**Re: SSD 6954 IKEA Multi-Function Logistics Unit, Sydney Business Park,
Marsden Park**

ATTACHMENT A

Existing Conditions
Catchment Plan

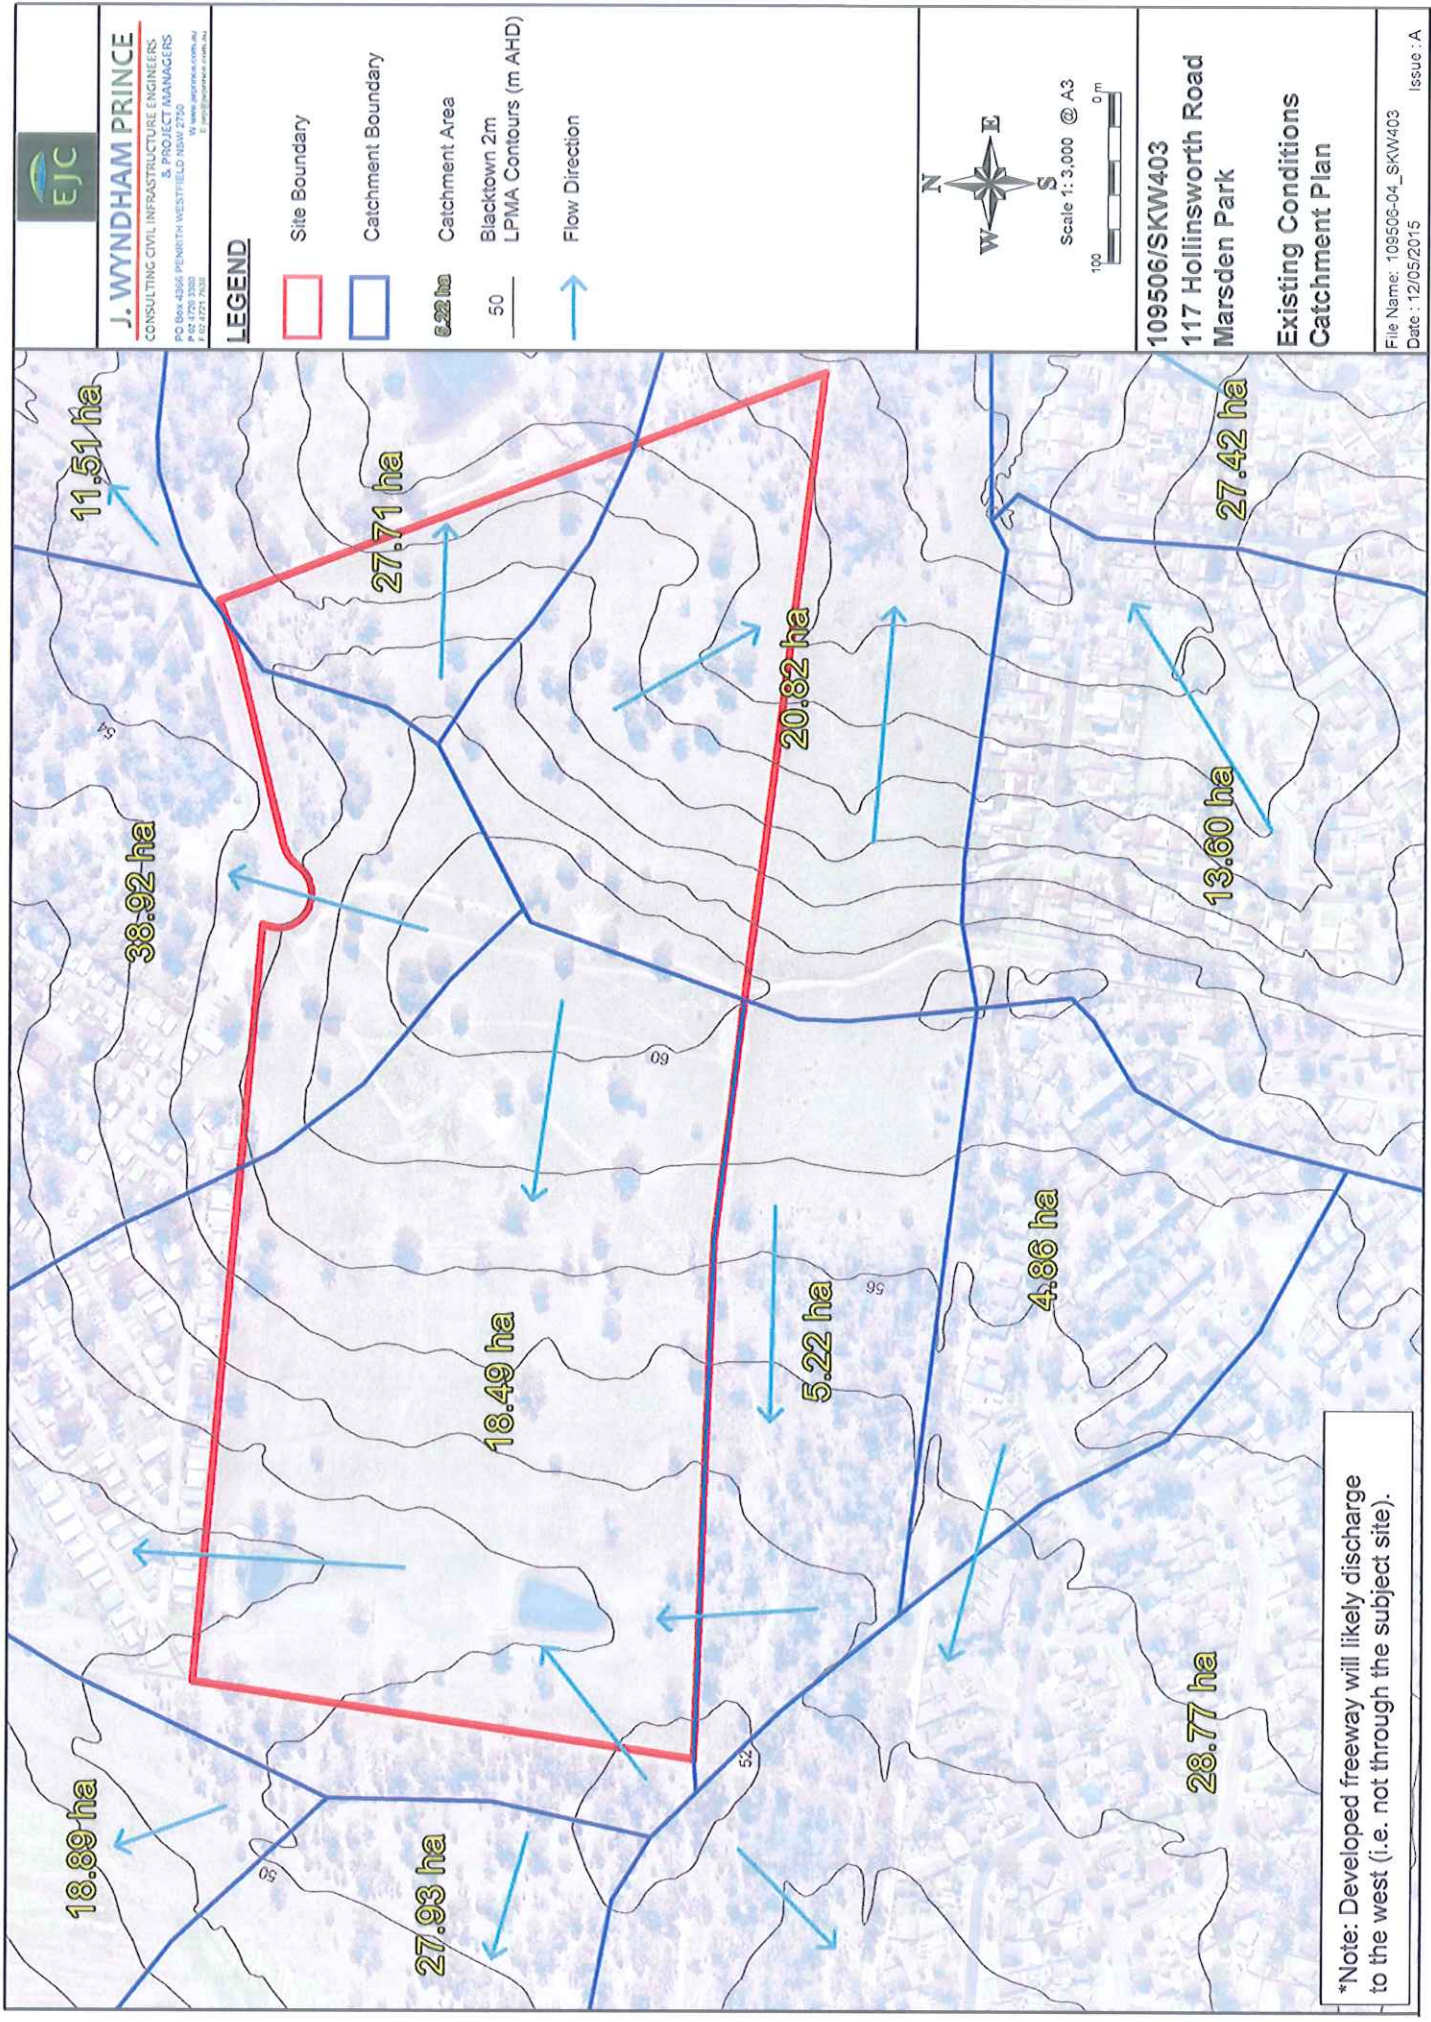
- a) The XPRAFTS model provided is not for the study area. The correct model is to be provided to verify basin and culvert sizing.
- b) The Calibre design flows for culvert M1.9 are significantly different to those quoted for the precinct planning. A full catchment plan and the correct hydrologic model is required to confirm the design flows for this culvert. There has been a change in the catchment draining to this culvert as a result of more detailed post precinct planning investigations (see the attached Existing Conditions Catchment Plan prepared by J. Wyndham Prince, reference 109506-04_SKW403, Issue A, Dated 12 May 2015). The design invert levels for this culvert are significantly lower than those assumed for the S94 design concepts. Proposed concept design levels/longsection are required for the downstream channel and basin to demonstrate that the proposed culvert levels work with the proposed downstream infrastructure.
